**TOWN OF BROOKLYN
PLANNING AND ZONING COMMISSION
Special Meeting Agenda
Tuesday, July 18, 2023 6:30 p.m.**

ENGINEERING SITE PLAN & DRAINAGE REPORT REVIEW

SPECIAL PERMIT SITE DEVELOPMENT PLAN

The comments contained herein pertain to my review of a set of plans, consisting of fifteen (15) sheets (sheet 15 architectural missing), entitled "Special Permit Site Development Plan Prepared for Townsend Development Associates, LLC, Providence Road (Route 6), Brooklyn, Connecticut, Dated: May 5, 2023, Revised: N/A," prepared by CHA and Drainage Report, dated May 24, 2023, by CHA.

Drawing No. 2 (Sheet 1 of 1) – Improvement Location Plan

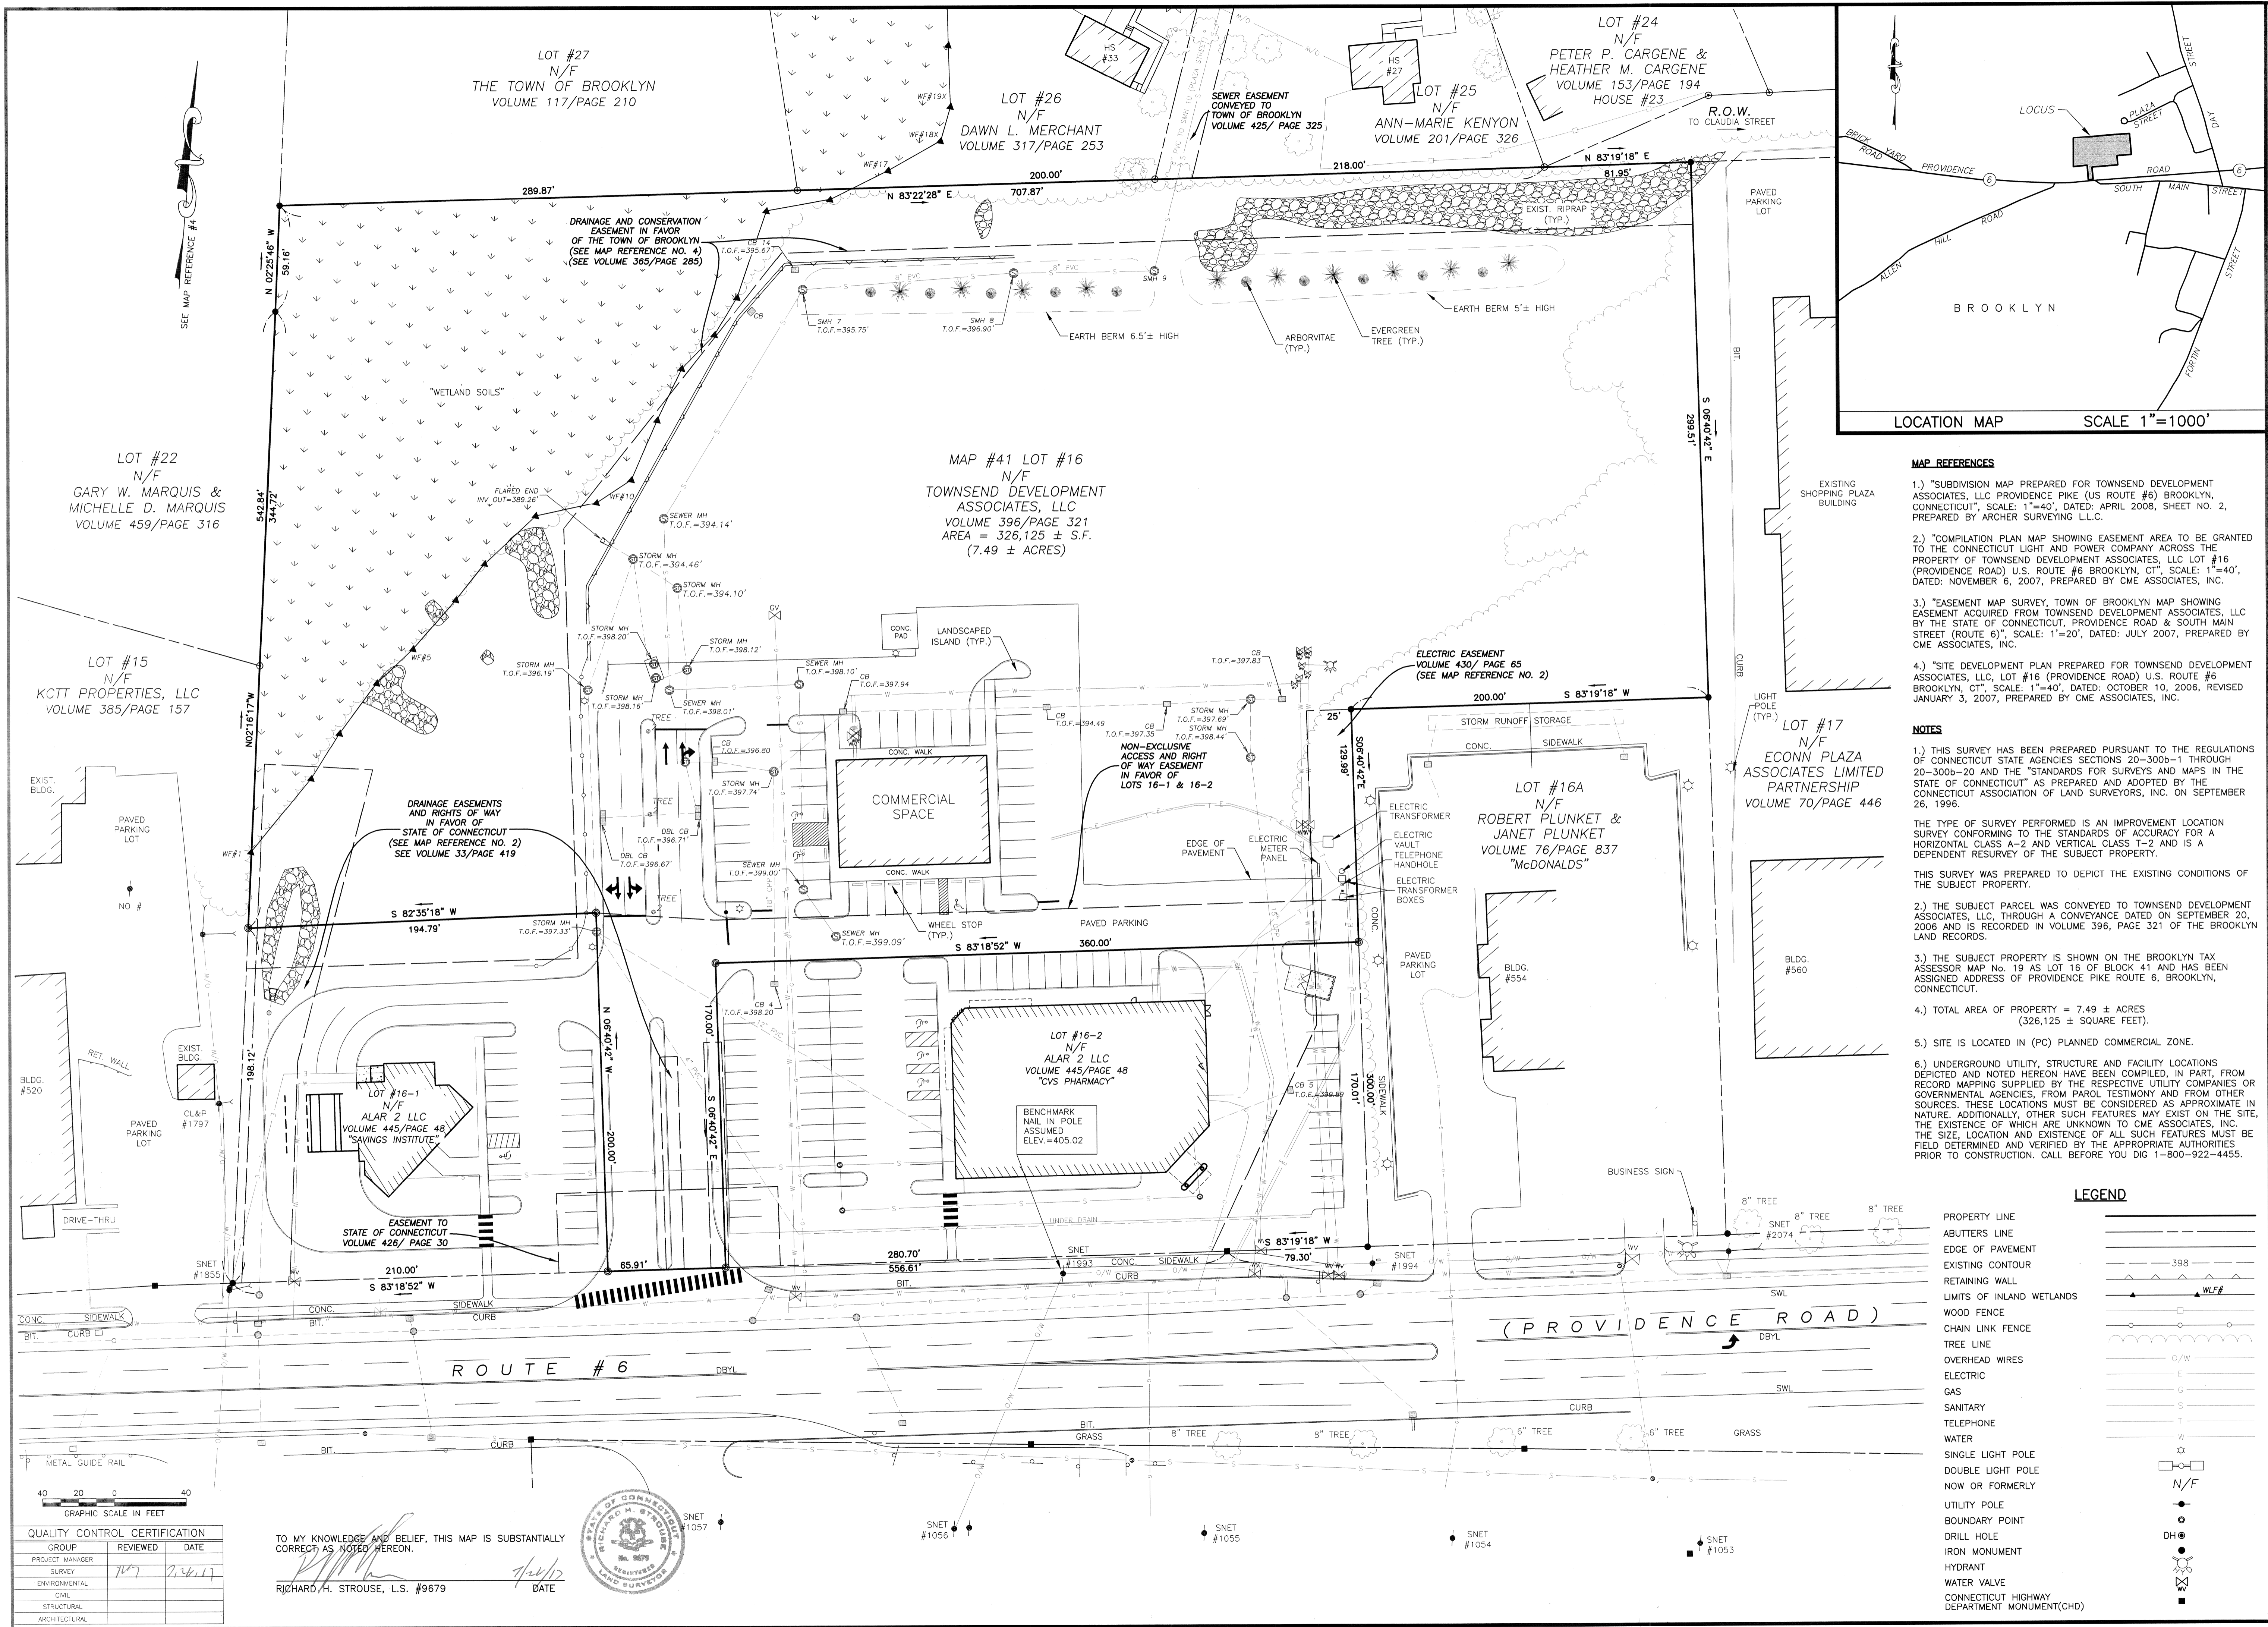
1. Not all sidewalks shown are dimensioned. All sidewalk widths need to be specified on the plan.
2. If the sidewalk at the south end of the proposed crosswalk is not flush with the pavement, a sidewalk ramp will need to be constructed there and a construction detail provided — see Type 17 on CT DOT "Sheet 6 – Sidewalk Ramps."

(CT DOT) 48" wide ramp with landing detail drawing that can be found on their "Sheet 1 - Sidewalk Ramps."
